Approval	Signature	Date	 5364 Valley Mist Trace Norcross, GA 30092 770-814-0683 ncsradio@ncsradio.com	Title
Engineering				3240, Modification for External Control Output
Design				
Product				
Manufacturing

## 1.0 Purpose

This modification provides a dry contact relay output that is closed when a radio is selected. The output is obtained on the Left Audio input jack on the rear panel for the selected radio. **After this modification, the Left Audio channel is no longer available for use as an audio channel; only single channel (mono) audio switching using the Right Audio channel will be available.**

Figure 1

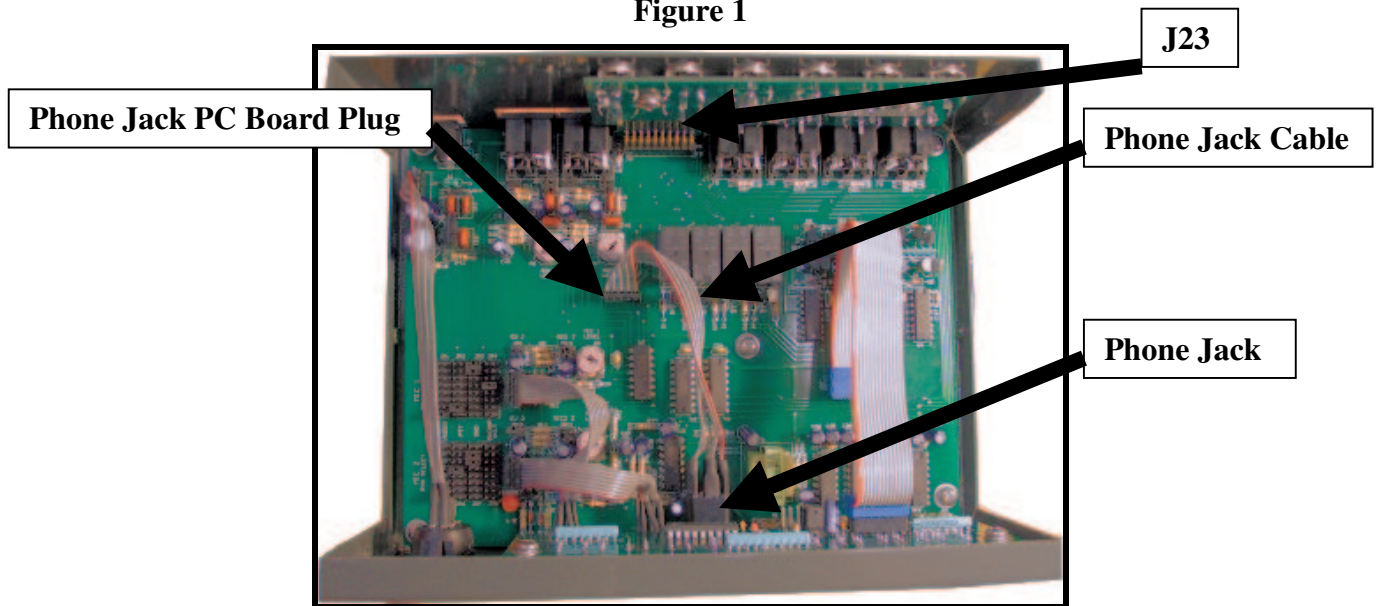
- 2.1 Remove the Multi-Switcher cover by removing the 3 screws on each side of the unit.
- 2.2 Unplug the Phone Jack PC Board Plug identified in Figure 1.
- 2.3 Remove the phone jack from the front panel using a nutdriver.
- 2.4 Unsolder the wires from pins 1 and 3 of the phone jack. See below for pin identification.
- 2.5 Solder these two wires together and insulate with electrical tape or heatshrink tubing.
- 2.6 Solder a short piece of insulated wire between pins 1 and 4.
- 2.7 Re-install the phone jack being sure to plug the PC Board connector in with the red wire toward the right-hand side of the unit.
- 2.8 Solder a short piece of wire between the center pin and one shell pin on J23 (Left Speaker Output). See Figure 2 for jack identification. Removal of the rear connector board is not necessary.
- 2.9 Replace the Multi-Switcher cover using the 6 screws removed in step 2.1.

Figure 2

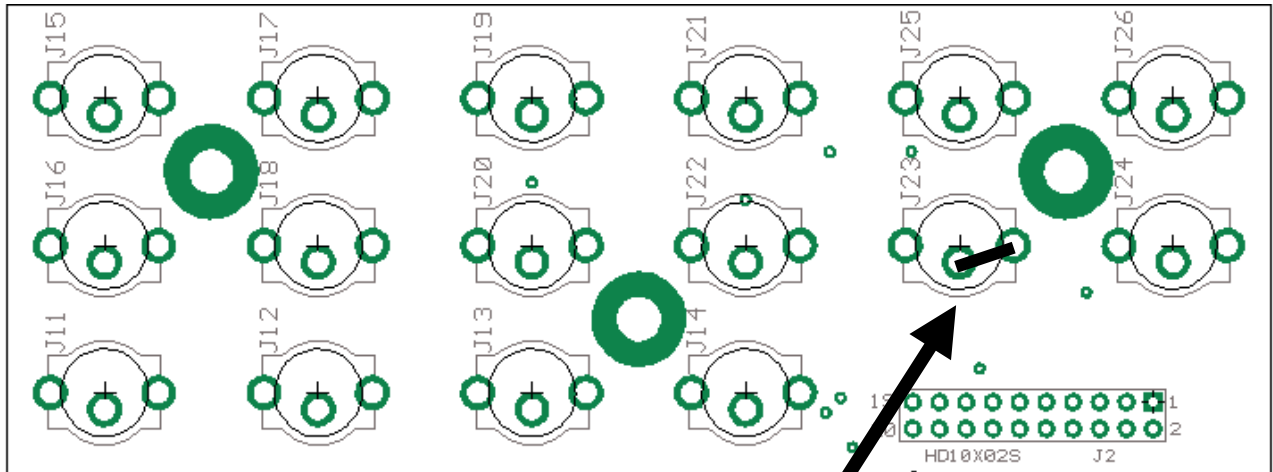
Add jumper wire on solder side of board here.  
NOTE: Connector side of board shown in this view. Put jumper on other side.
